**SANITARY SEWER  
TO SERVE  
PRESBYTERIAN MANOR**

PROJECT NO. 2160PPS

AS BUILTS	
Contractor: McCullough Excavation, Inc.  10/09/2013	Project Inspector: Tom Jones  <b>kemiller</b> engineering 516 S. Market Wichita, KS 67202 (316)244-0242

**SANITARY SEWER PLANS FOR  
PRESBYTERIAN MANOR  
WICHITA, KANSAS**

**PLAN LINE 1**  
**PROFILE LINE 1**

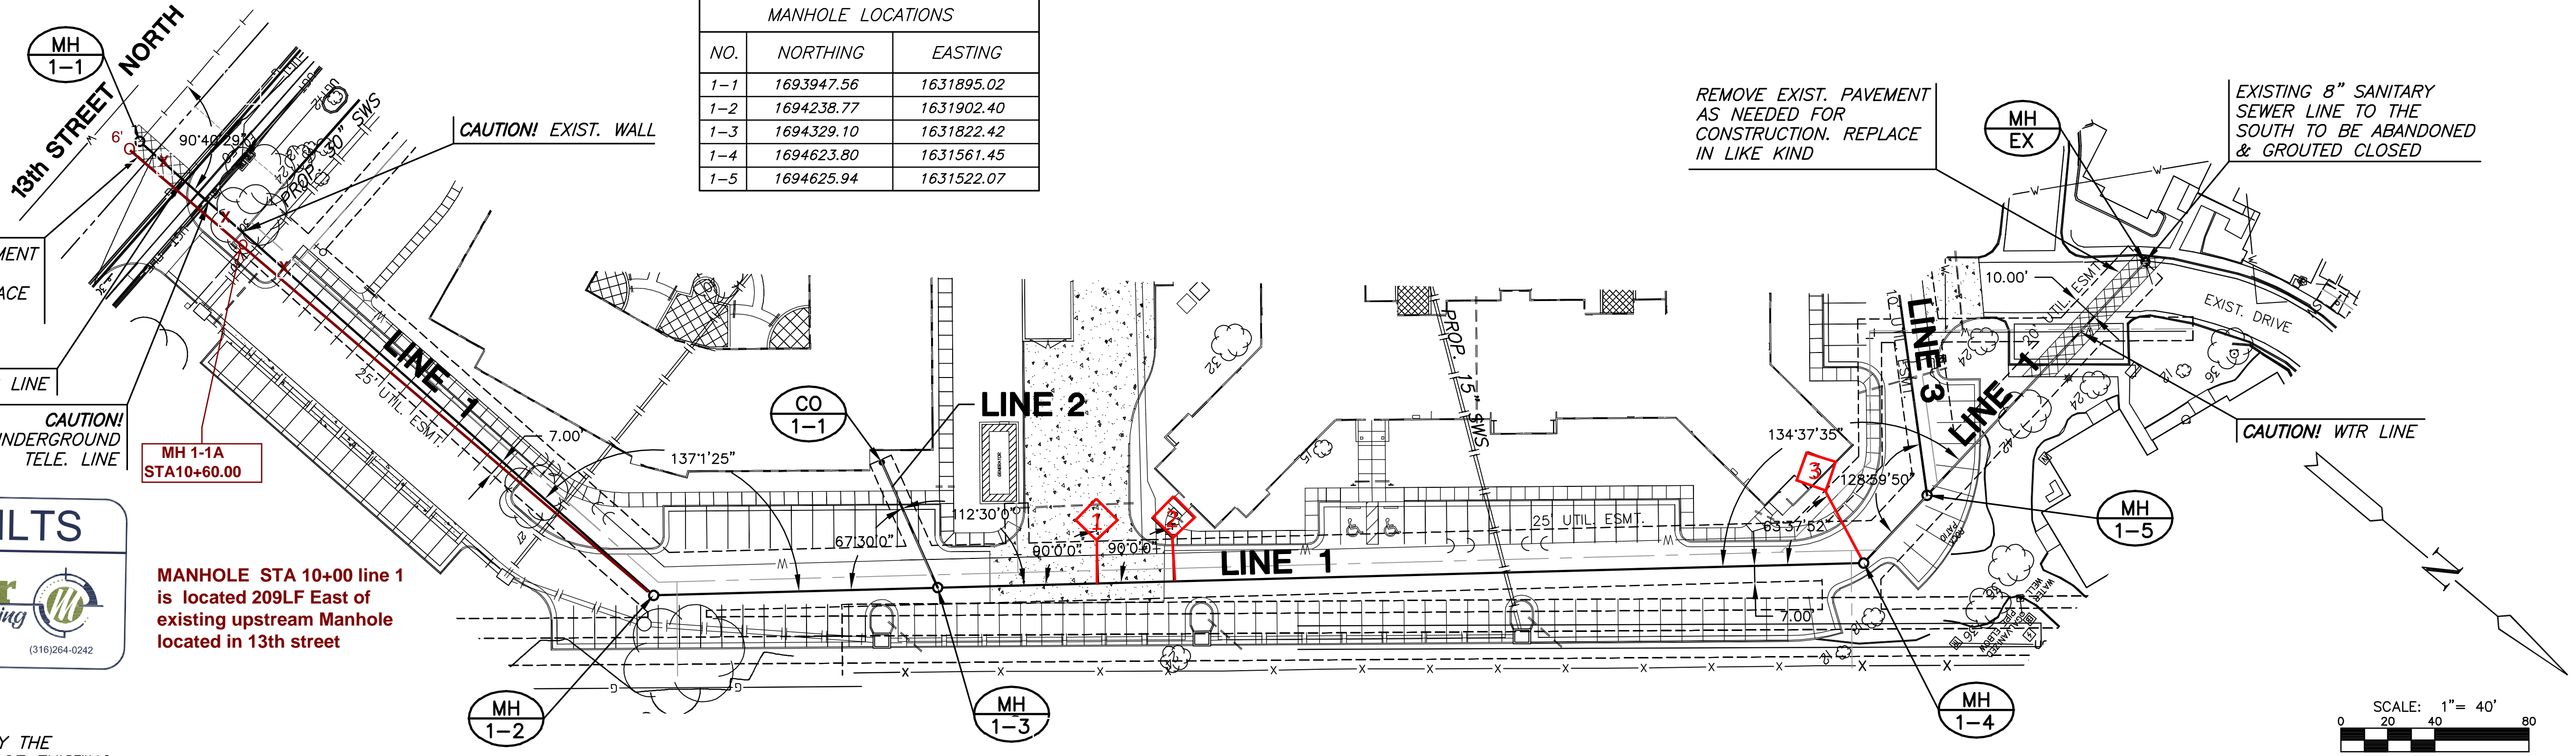
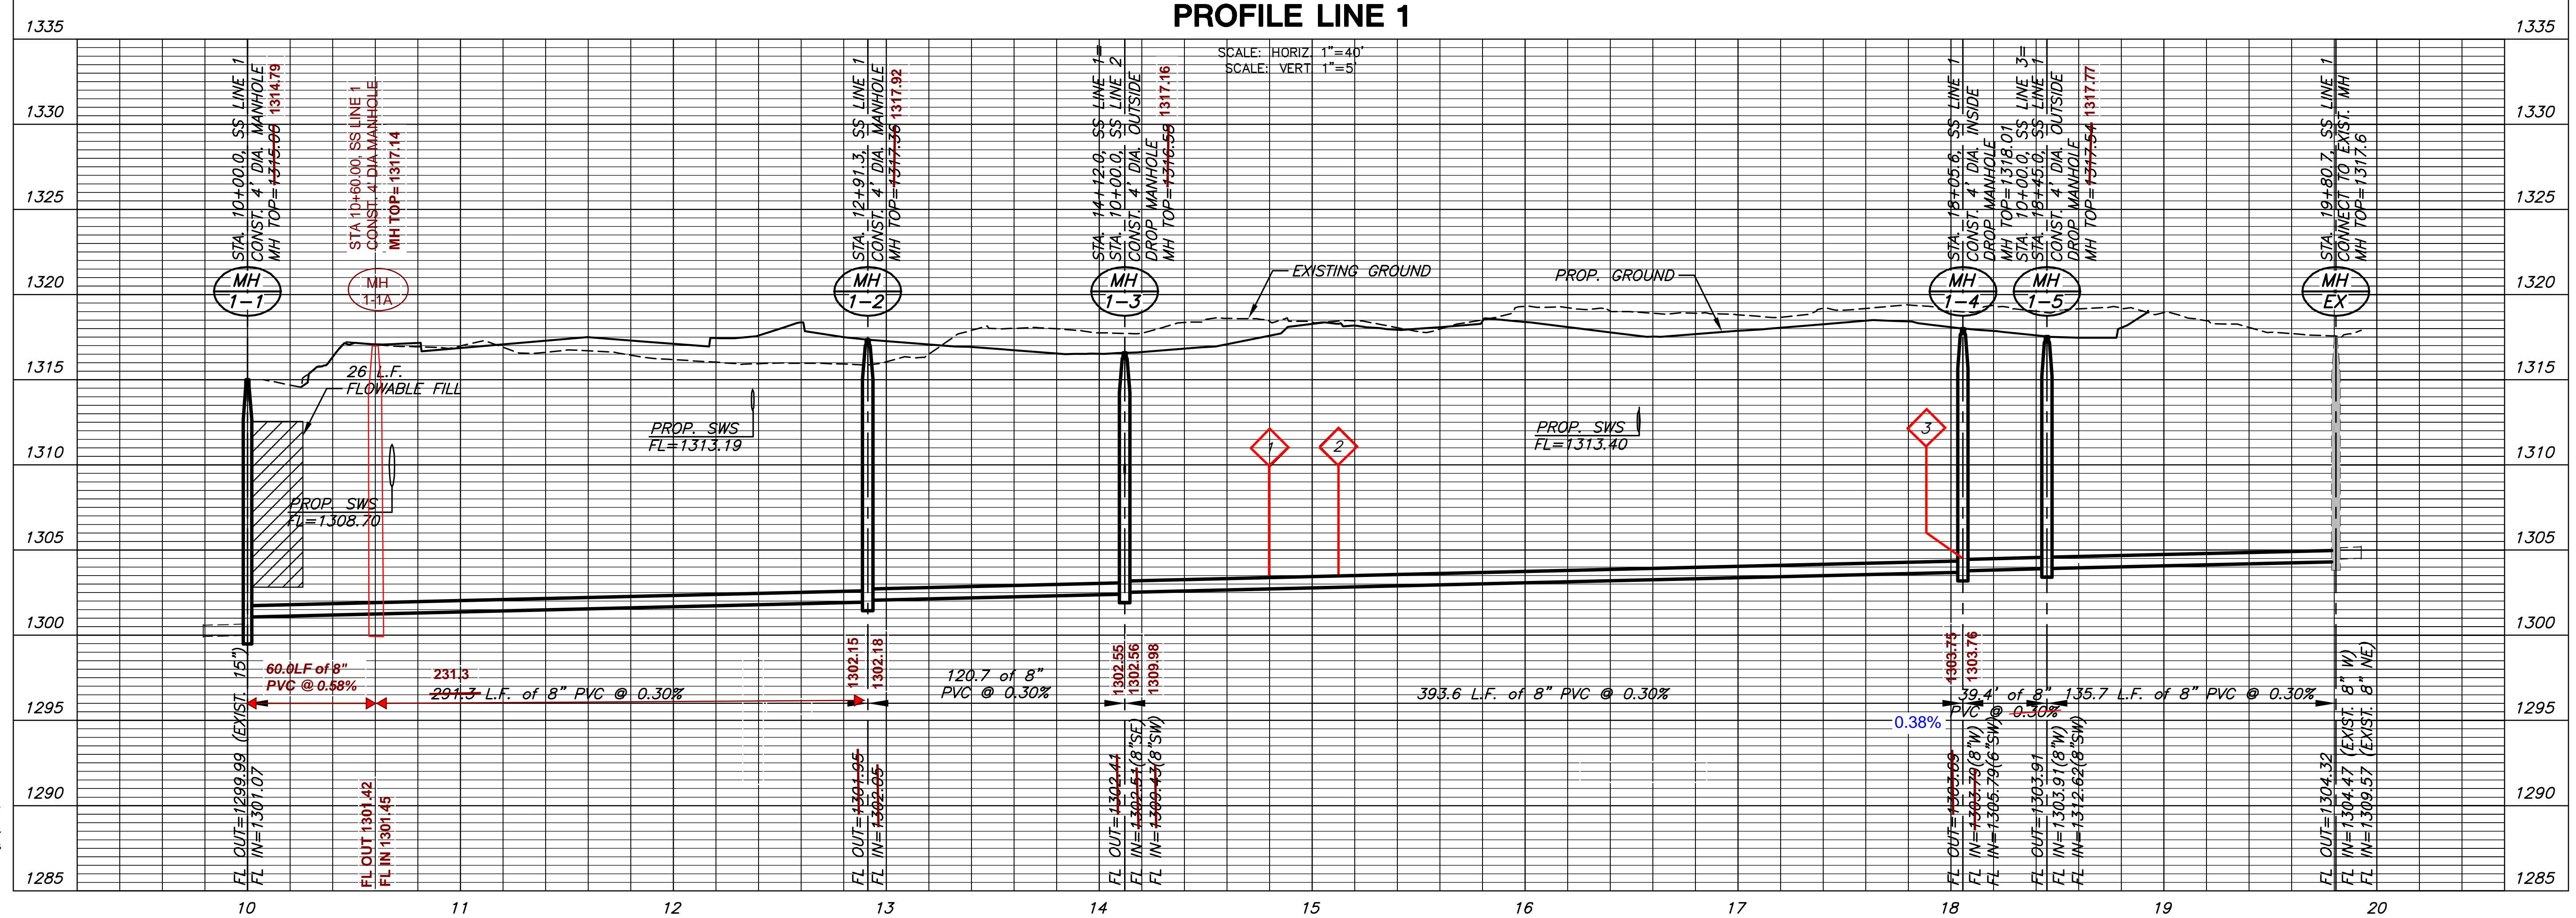
MH1-1 moved 6' East because of power pole  
MH-1 moved 2' South to be over 15" clay tile main

MANHOLE STA 10+00 line 1 is located 209LF East of existing upstream Manhole located in 13th street
